35 82-157-SPH **PETITION FOR SPECIAL HEARING** TO THE ZONING COMMISSIONER OF BALTIMORE COUNTY:

BALTIMORE COUNTY **ZONING PLANS** **ADVISORY COMMITTEE**

PETITION AND SITE PLAN **EVALUATION COMMENTS**

RE: Item No. 35
Petitioner - The Arundel Corporation
Special Hearing Petition

TOPOGRAPHIC MAP
OF
THE DELIGHT QUARRY
FOR
THE ARUNDEL CORPORATION
TOWSON, MARYLAND
DATE OF PHOTOGRAPHY: MARCH 22, 1981
SCALE: 1"=200' CONTOUR INTERVAL: 5'

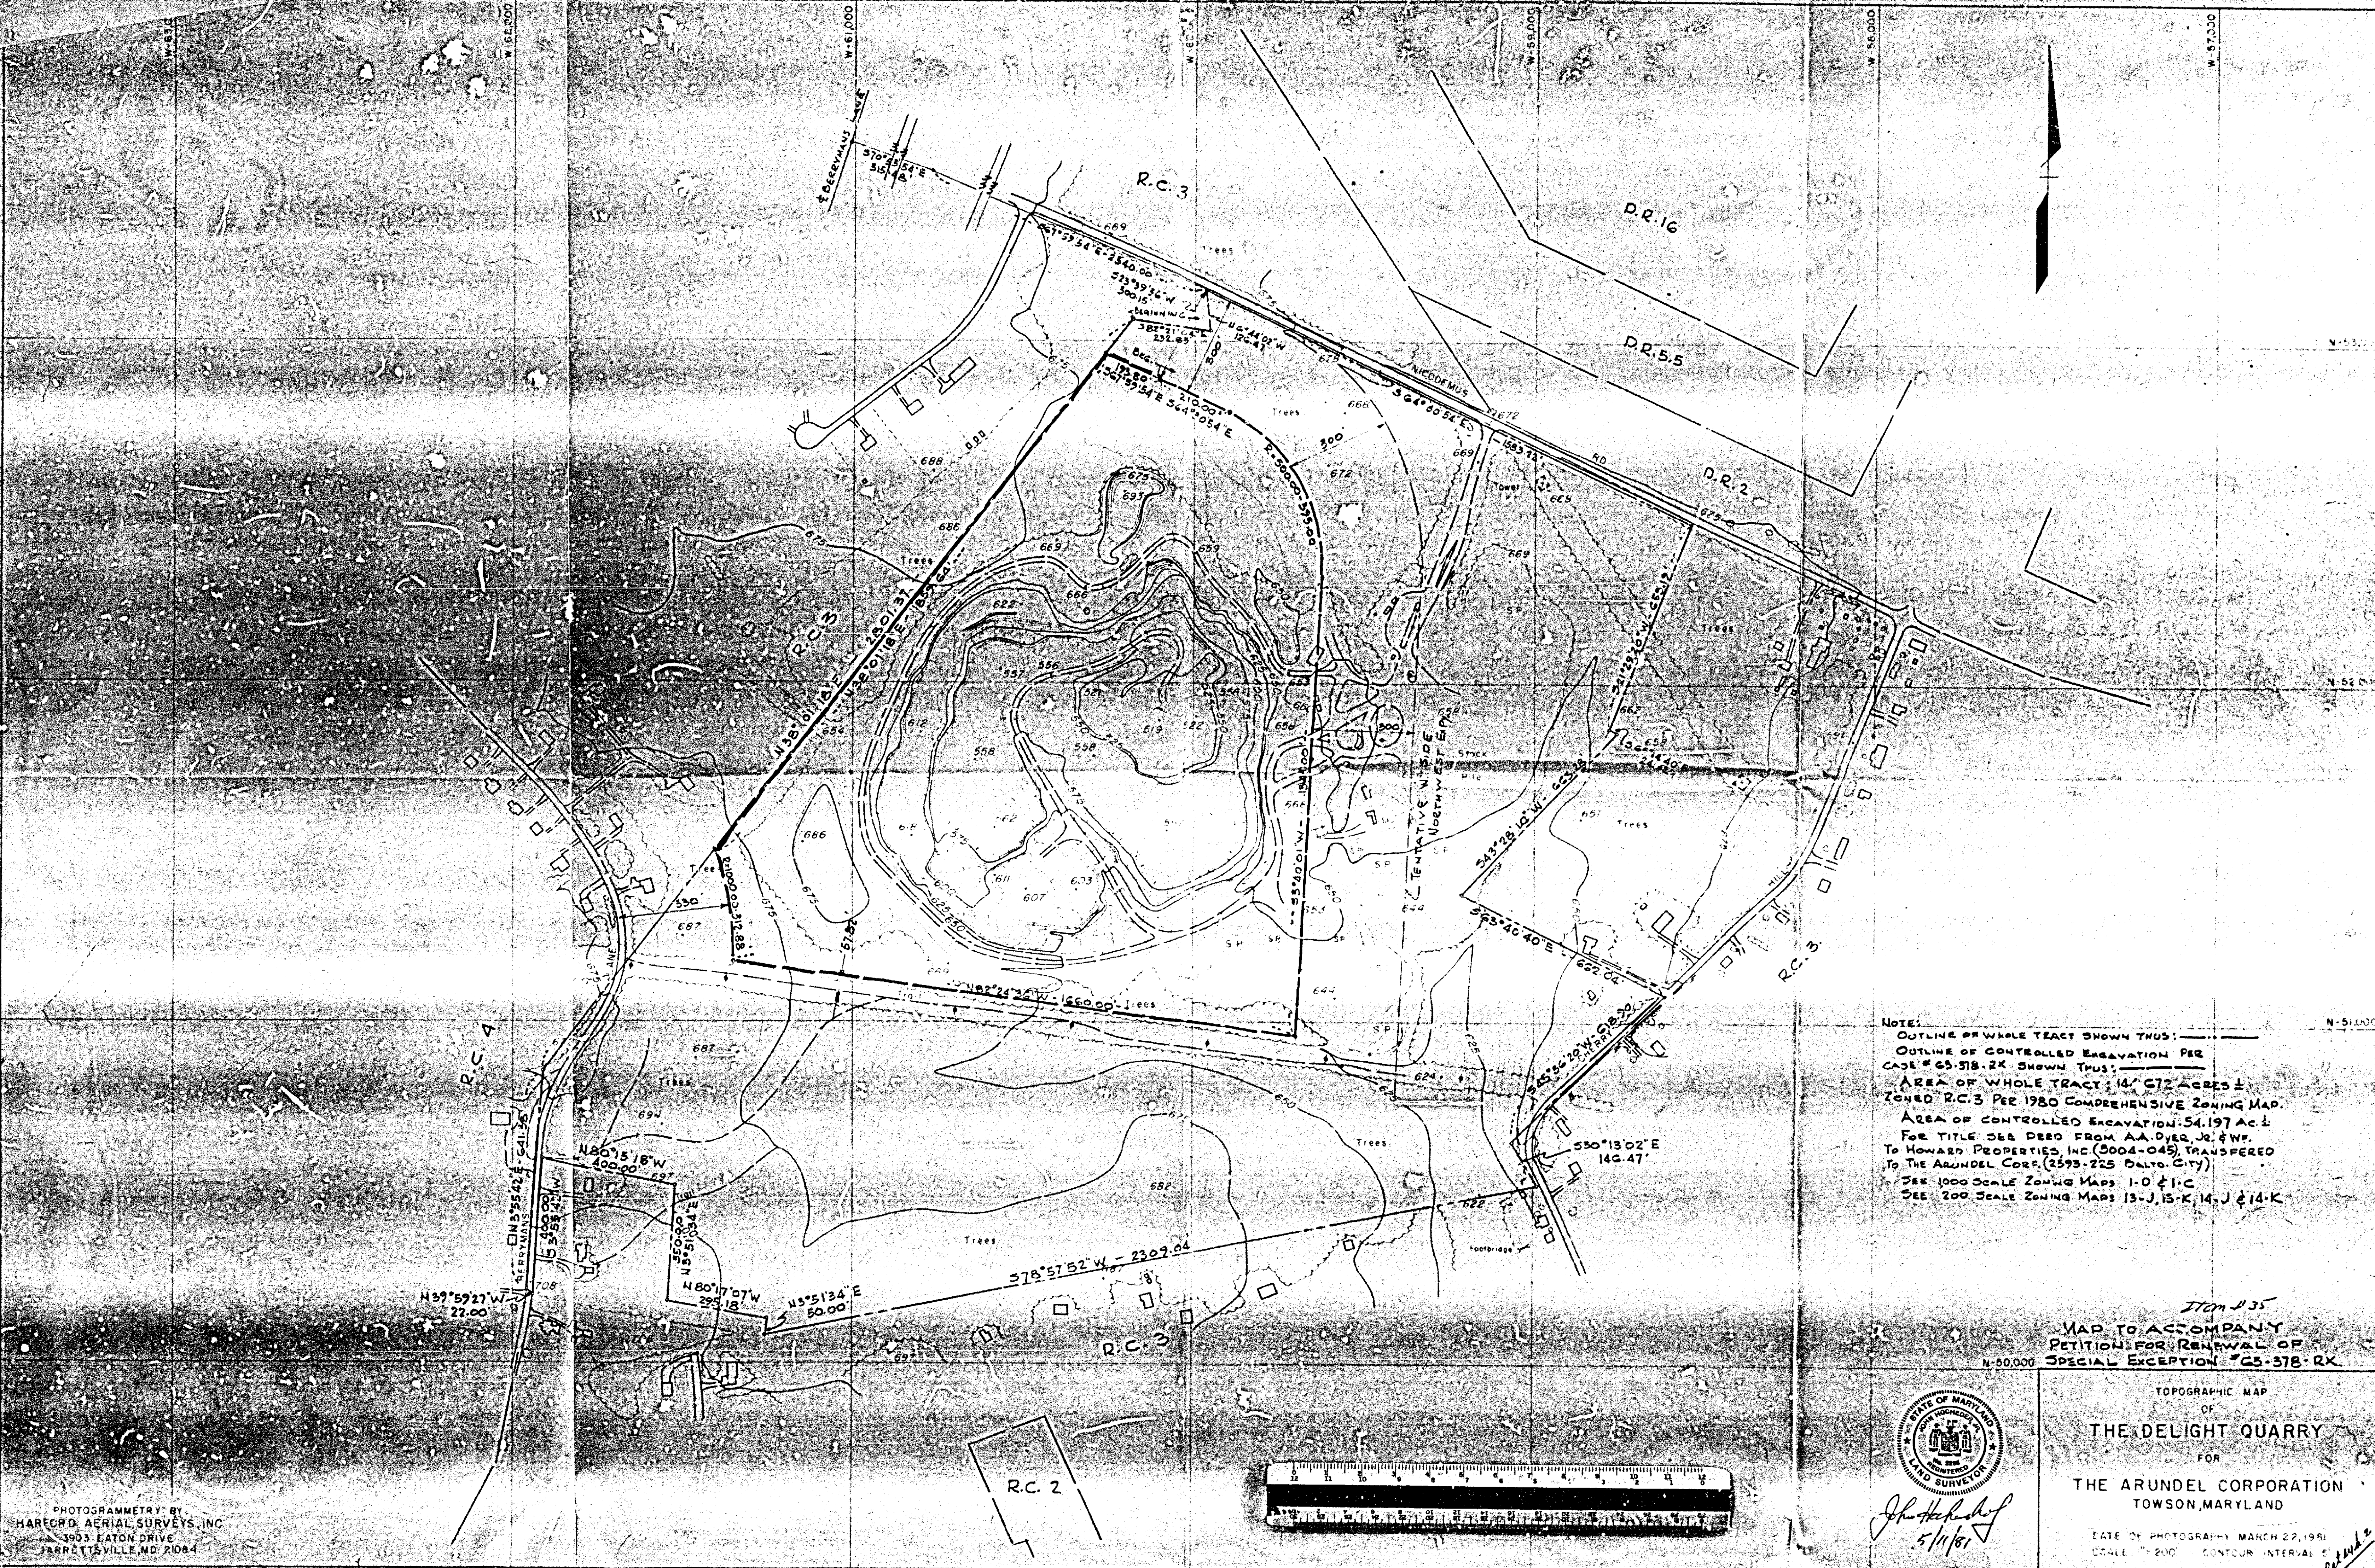
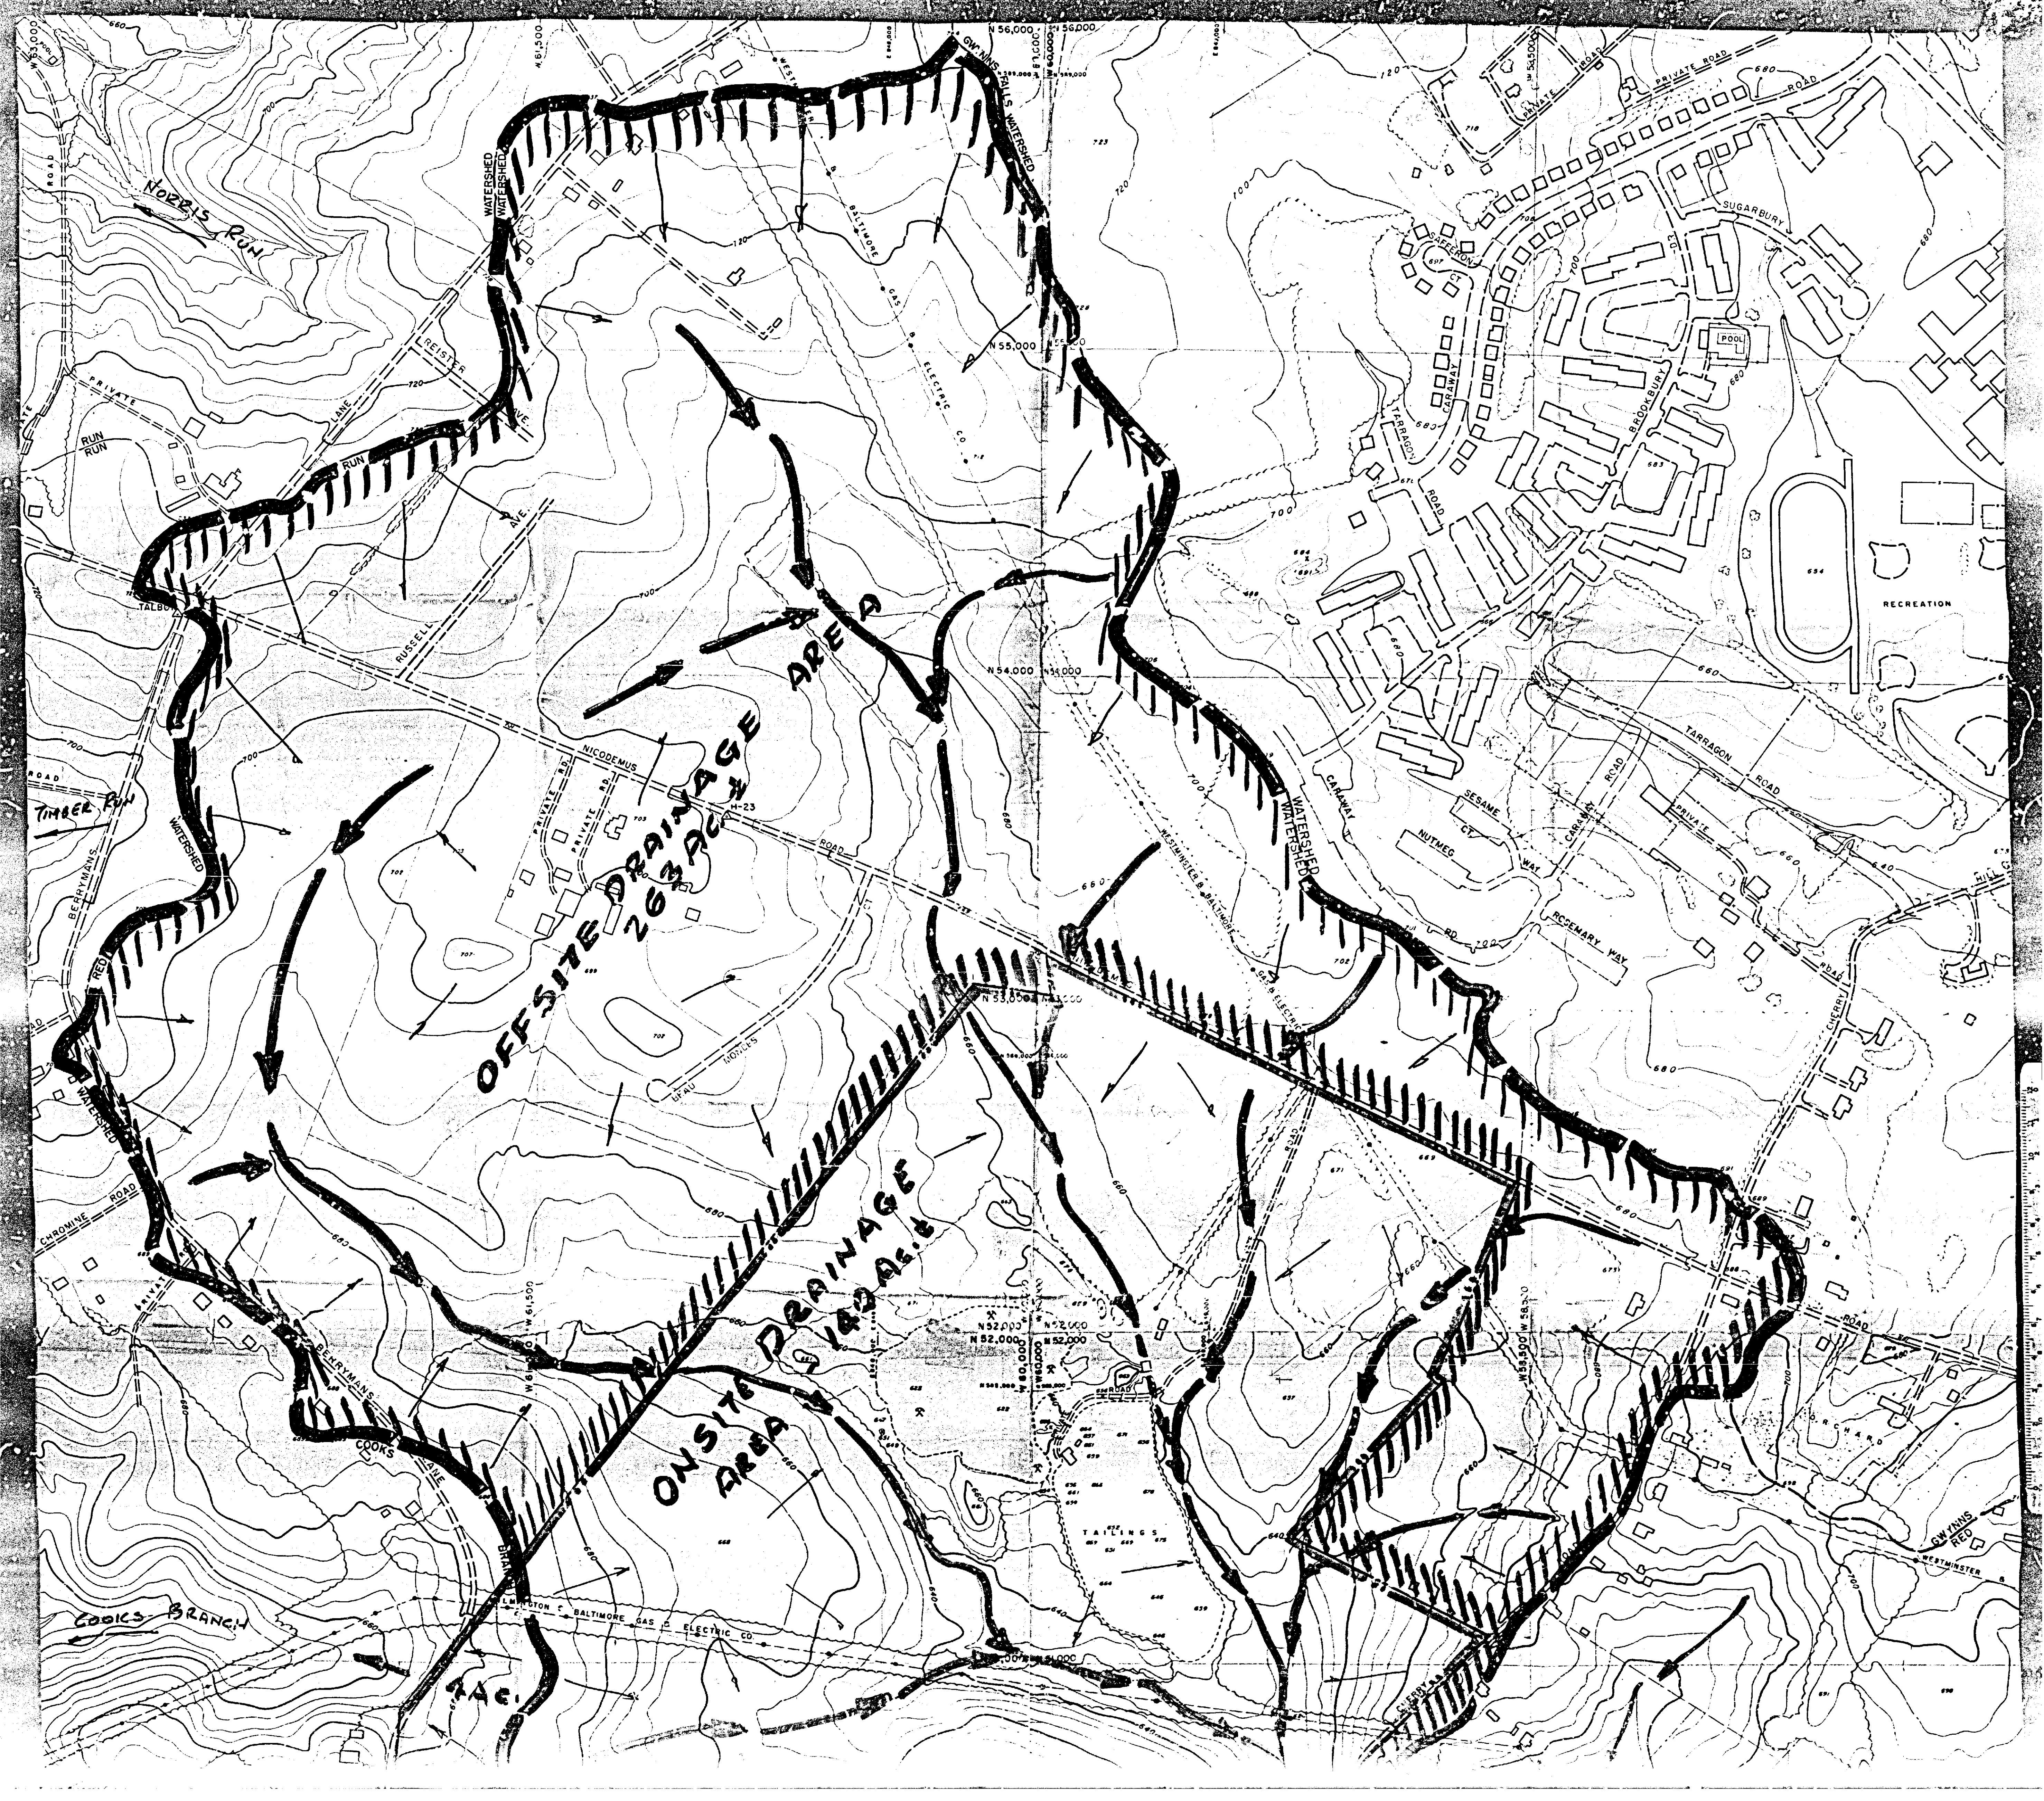
Provisions for accommodating storm water or drainage have not been indicated on the submitted plan.

As shown, several tributaries traverse this property.

The above drainage requires a drainage reservation or easement of sufficient width to cover the flood plain of a 100-year design storm. However, a minimum width of 50 feet is required.
